UNITED STATES PATENT AND TRADEMARK OFFICE

Office Action Summary	Application No. 10/552,838	Applicant(s) CHOI, YUN-SEOK	
	Examiner Sundhara M. Ganesan	Art Unit 3764

DETAILED ACTION

Fig. 1 of US Pat. 6,394,936 (annotated by examiner)

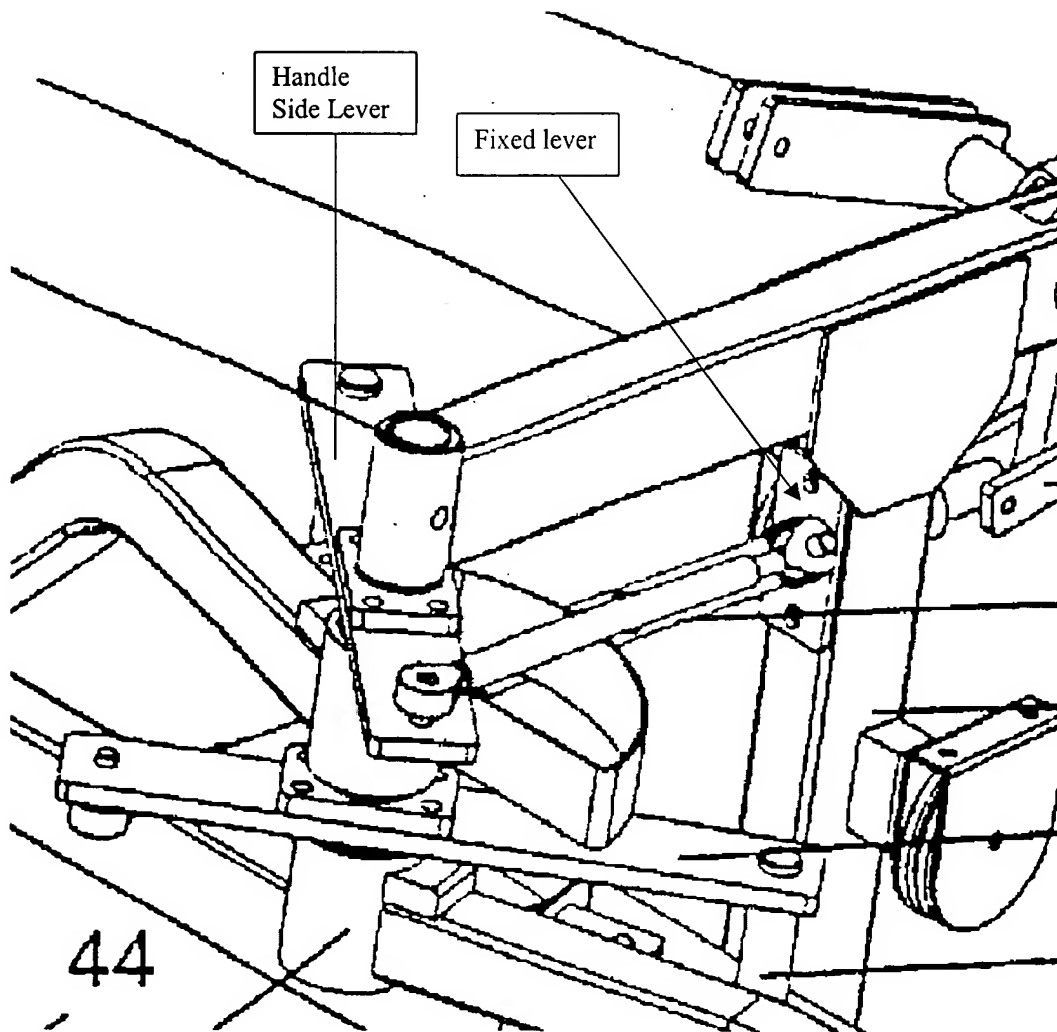
6. Claim 1 is rejected under 35 U.S.C. 103(a) as being unpatentable over Voris (US Pat. 6,394,936). Voris describes substantially the same invention as claimed, including: an I shaped base frame (10), a tower (20) mounted to the top surface of the I-shaped base frame, a seat (87) mounted on the base frame, handle linkages (31) each inclinedly mounted at right and left sides of the base frame via bearings (26) in such a manner as to form an angle α in front of the seat (Fig. 1) to perform angular motion back and forth; a bearing box (27) mounted on the front end of the handle linkage, first and second handle frames (24, on the left and right side of the machine) rotatably mounted on a handle shaft (26), the first handle frame being connected to the handle shaft, the second handle frame being connected to the handle shaft at an angle (Fig. 2); a handle side lever (28) fixed between the first handle frame and the bearingbox in such a manner as to form a predetermined angle with respect to the first handle frame (Fig. 1); and an auxiliary linkage (30) connected to an upper end to the handle side lever via a

ball joint (see Fig. 1) and mounted at lower end on a fixed lever (see Fig. Below) fixed to the base frame via a ball joint.

Voris does not show the fixed lever as being fixed to the lower end of the front side of the base frame.

At the time the invention was made, it would have been obvious to one having ordinary skill in the art to change the position of the arm assembly of Voris such that it is located on the lower front end of an exercise machine. The function and components

are the same; only the placement on the device is changed, which would allow for exercising different muscle groups. According to MPEP §2144.04, rearrangement of parts is not a patentable advance. The operation of the parts described by Voris and the operation of the invention described in claim 1 is identical except for the placement of the arm assembly. One having ordinary skill in the art could make this rearrangement with the motivation to exercise other muscle groups on the human body. See *In re Japikse*, 181 F.2d 1019, 86 USPQ 70 (CCPA 1950) and MPEP §2144.04 (VI).

Regarding claim 2, Voris shows the handle linkages as axially mounted to the base frame at angles for trapezoidally angular motion of the right and left directions (see Fig. 7, the trapezoidal motion is from the path of the two hands and the points B and B'); the auxiliary linkage (30) is connected to the fixed lever (see Fig. 1 annotated above) via the ball joint in front of or behind the lower portion of the handle linkage on the base frame and is separated from the handle linkage at a predetermined distance; the ball joints located on the upper and lower portions of the auxiliary linkage (30) are arranged in a perpendicular direction to each other (Fig. 1); the bearing box (27) is fixedly mounted on the lower end of the handle linkage so that the handle shaft (26) is axially mounted to the bearing box (27) at an angle; the first handle frame is fixed to the handle shaft (Fig. 2) axially mounted to the bearing box (27) and the second handle frame is connected to the handle shaft at an angle in such a manner as to adjust an angle of a handle or to mount two or more handles (Fig. 2); the handle side lever (Fig. 1 annotated as above) is fixed between the bearing box and the first handle frame mounted on the handle shaft (26) to form a predetermined angle with respect to the handle frame (see

Fig. 1 annotation above); the handle side lever is connected to the auxiliary linkage via the ball joint and perform an angular motion in a direction of motion in a direction similar to the direction of an angular motion of the handle shaft for a smooth angular motion of the ball joint (Fig. 1 and 7).
